NEDO-24076-1
79NED27
CLASS I
MAY 1979

**DESIGN REPORT AND SAFETY
EVALUATION FOR HIGH DENSITY
FUEL STORAGE SYSTEM
AMENDMENT NO. 1**

Amendment No. 1

Figure A-1. Spent Fuel Storage Tube-Type II (10-10-78)

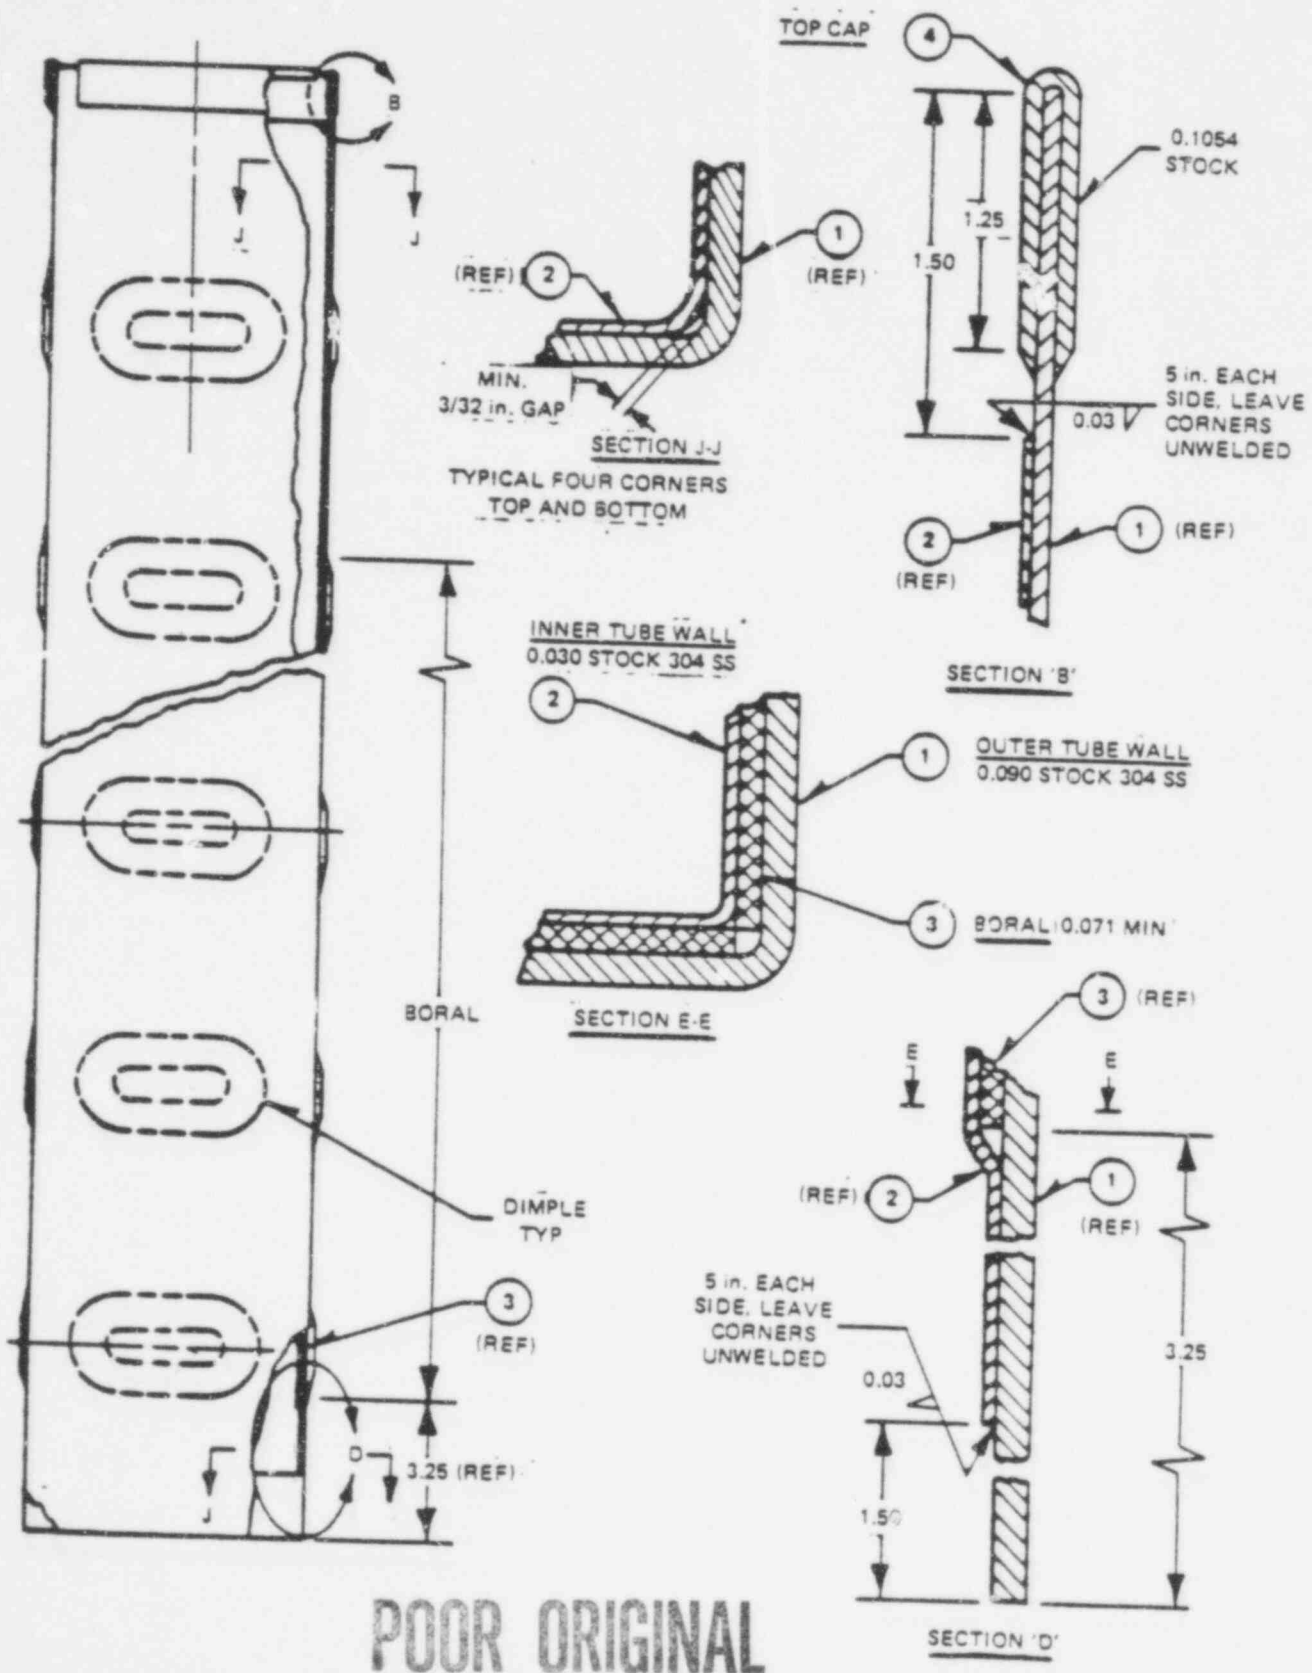
The spent fuel storage tube has been modified as shown in Figure A-1 to provide openings at both top and bottom of the tube in each of the four corners. Section J-J and notes on Section B and Section D indicate that the openings will be provided by not welding the inner and outer walls together in the corners.

The inner tube wall was made thinner (from 0.036 stock to 0.030 stock) to improve material costs as indicated on Section E-E.
